FED. ROAD DIST. NO.	STATE	FED. AID PROJ. NO.	FISCAL YEAR	SHEET NO.	TOTAL SHEETS
HAWAII	HAW.	F-058-1(1)	1990	17	29

**TRAFFIC SIGNAL PLAN
AT KAUMUALII HWY.**

NAWILIWILI ROAD REALIGNMENT
HALEHAKA ROAD TO KAUMUALII HIGHWAY
FED. AID PROJECT NO. F-058-1(1)
SCALE: AS NOTED DATE: Sept. 1989

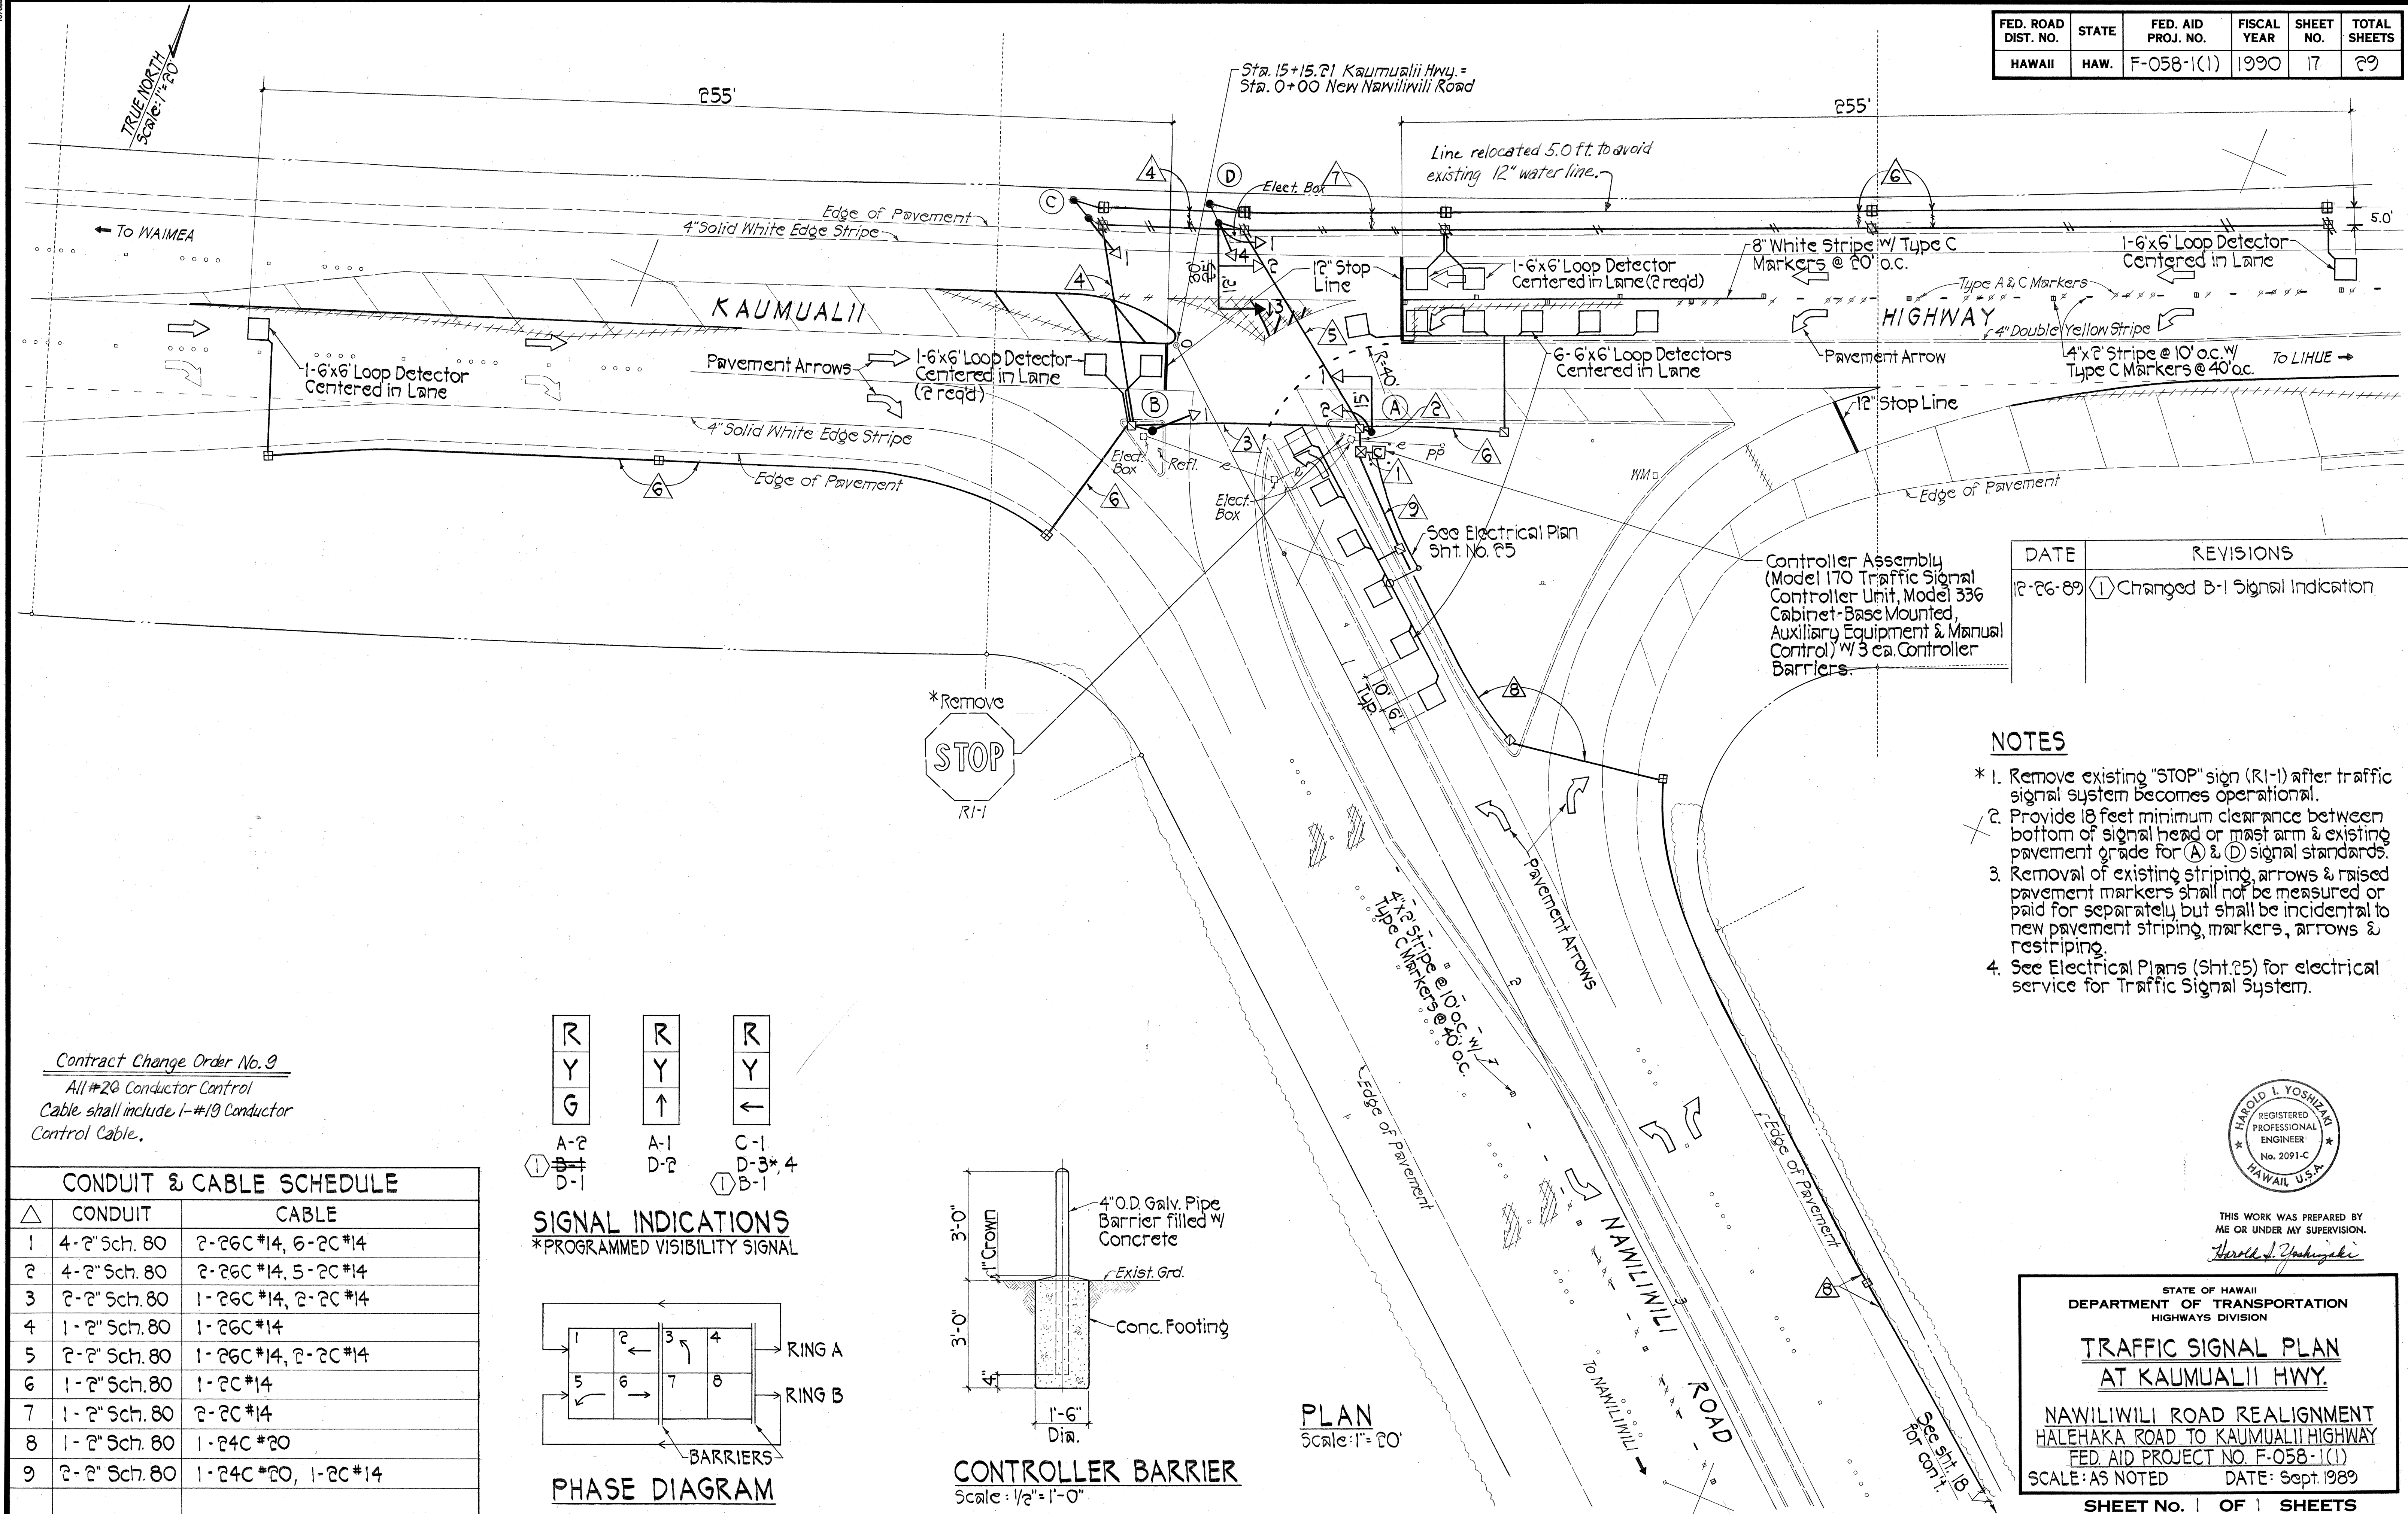
DATE	REVISIONS
12-26-89	① Changed B-1 Signal Indication.

Contract Change Order No. 9
 All #20 Conductor Control
 Cable shall include 1-#19 Conductor
 Control Cable.
